UNITED STATES PATENT AND TRADEMARK OFFICE

10/628,609

Office Action Summary

DETAILED ACTION

FIG. 4

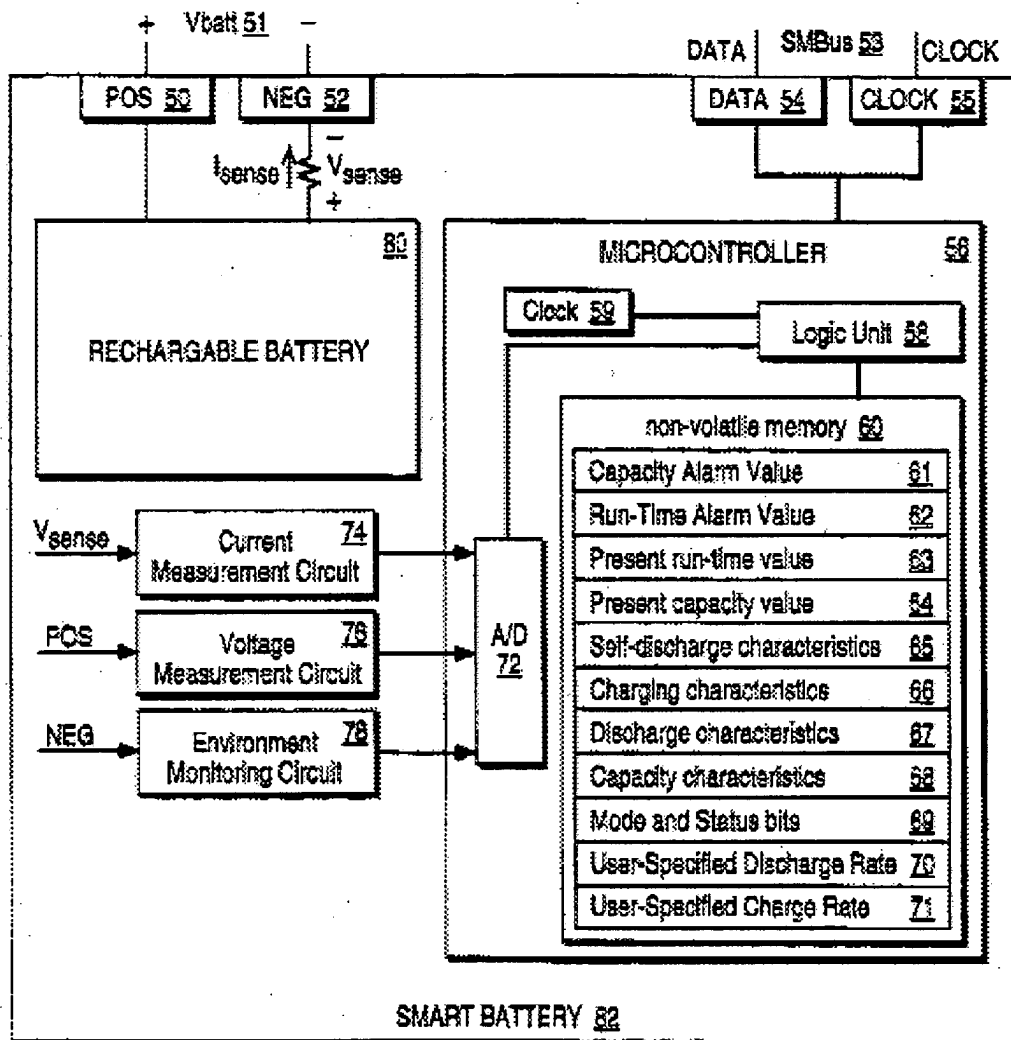
4. Dunstan discloses a smart battery power availability feature based on battery-specific characteristics. Most notable are Figs. 4 and 12 reproduced below.

9. As per dependent claims 2-3, the plurality of charging states, and noting that numerous self-identifying batteries will have numerous different charging characteristics, see at least the charging characteristics 66, mode and status bits 69, or user-specified charge rate 71 of Fig. 4, or the table in col. 14 of Dunstan.

FIG. 12

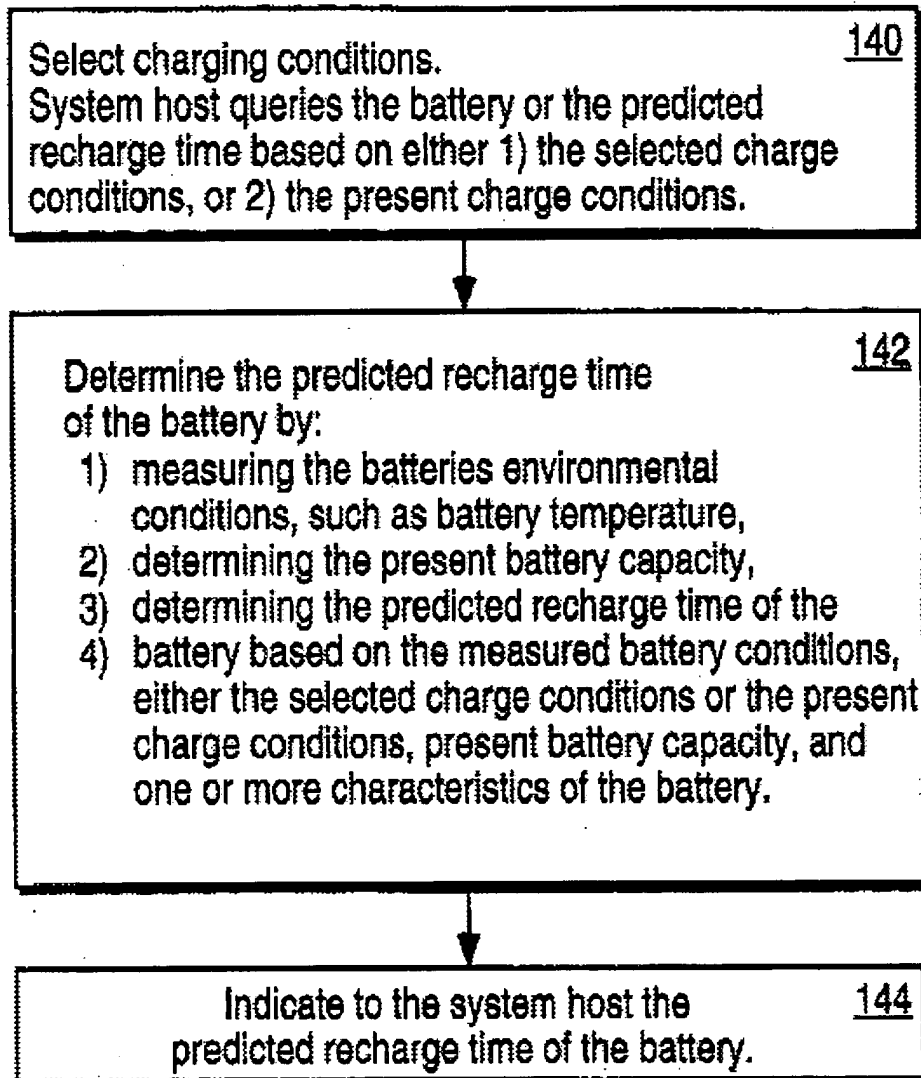
adding the first and the...second time to completion" is seen in at least Fig. 12

Note that the Smart Battery of Dunstan may be initially in a plurality of charging states and that the "predicted recharge time" of step 142 of Fig. 12 of Dunstan is specifically a function of "measured battery conditions, either the selected charge conditions or the present charge conditions, present battery capacity, and one or more characteristics of the battery."

10. As per dependent claim 4, see at least step 140 of Fig. 12 of Dunstan which is the "system host queries the battery or the predicted recharge time based on either 1) the selected charge conditions, or 2) the present charge conditions."

FIG. 3

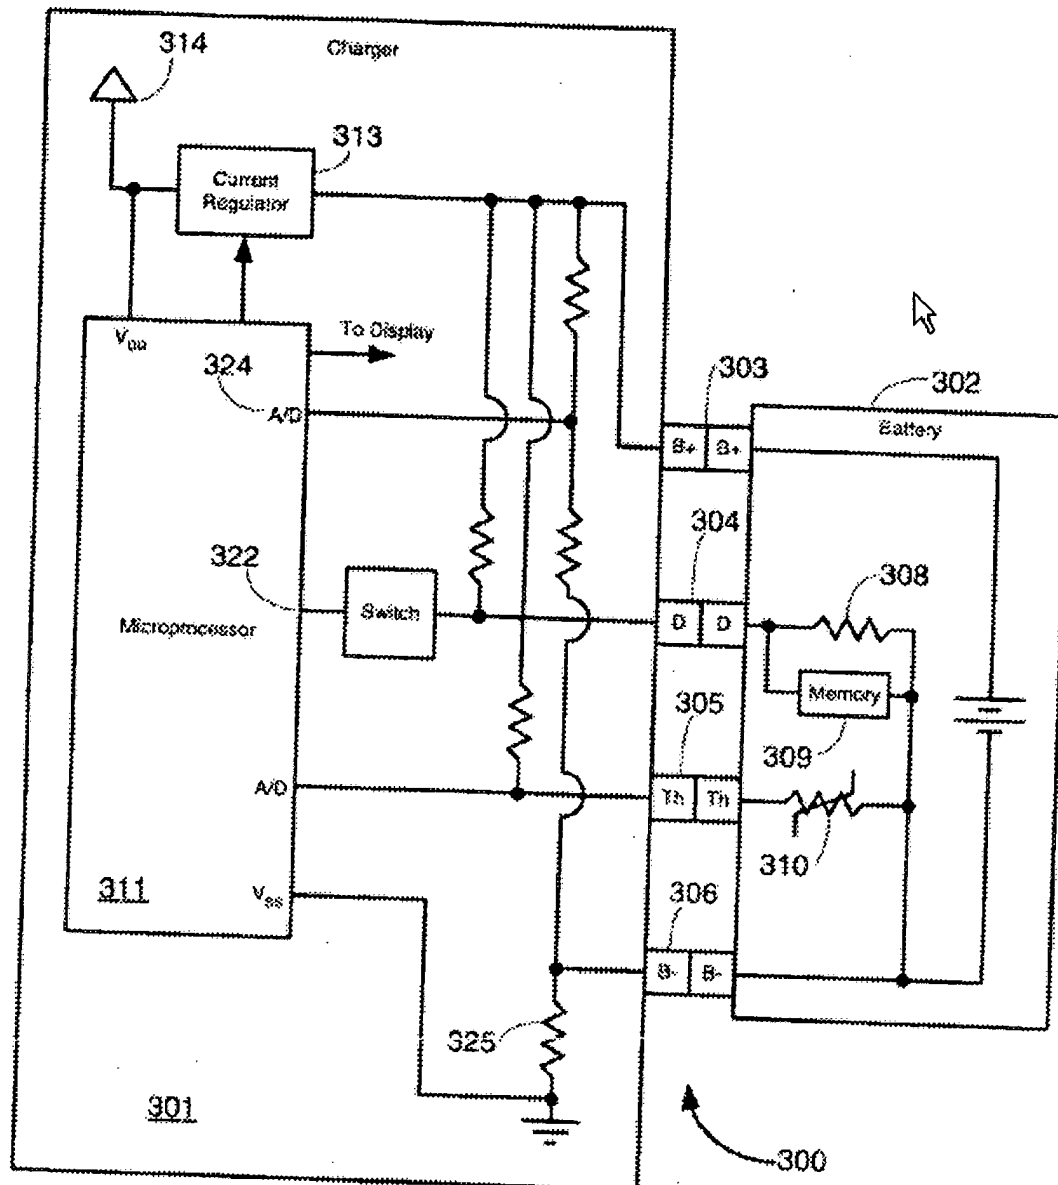
However, in light of the claimed means-plus-function language, we must turn to the instant Specification, and we see that Fig. 3 (reproduced below) shows such a means and this means may not be entirely equivalent to that of Dunstan.

FIG. 5

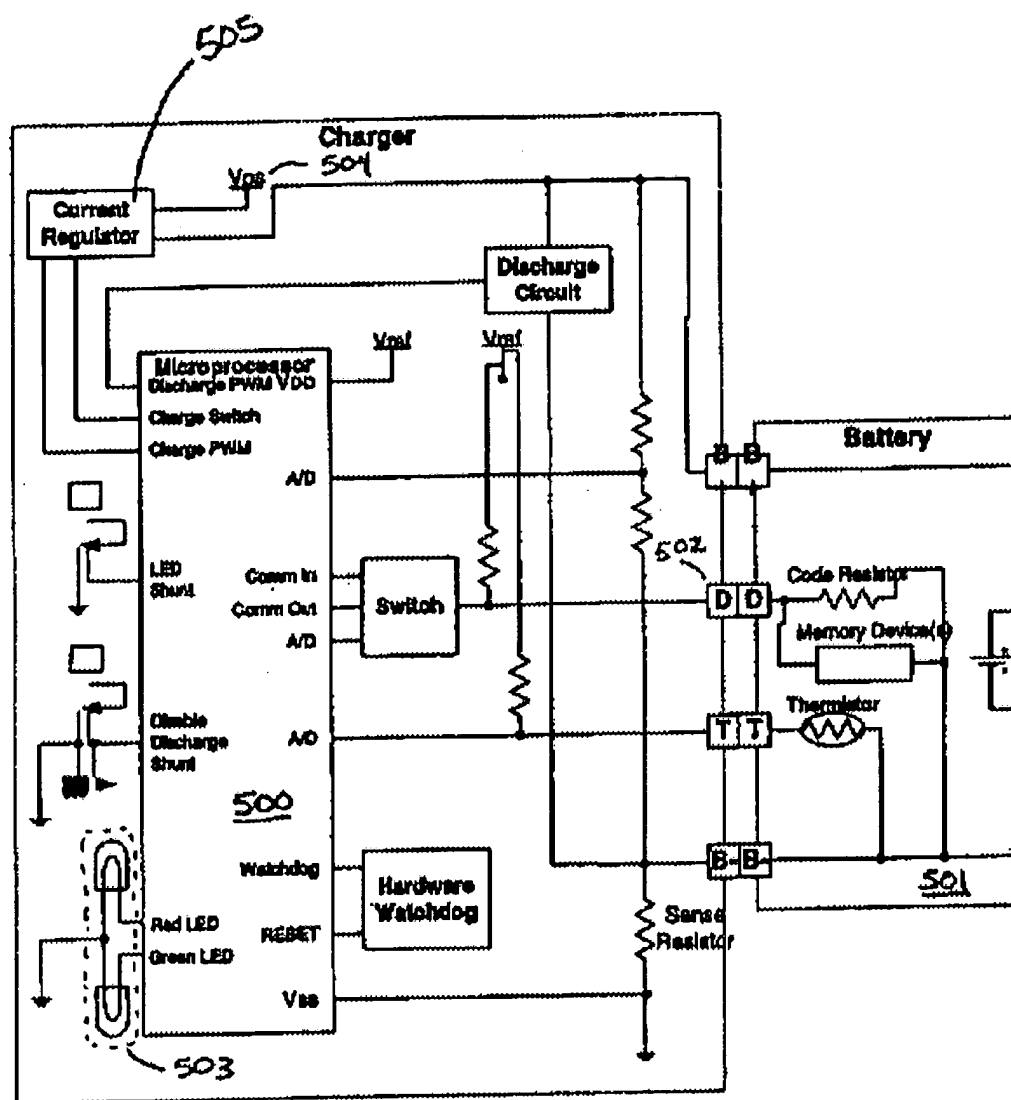
7. Maggert et al. however teach a substantially identical charger or charging means in their Fig. 5 reproduced below.
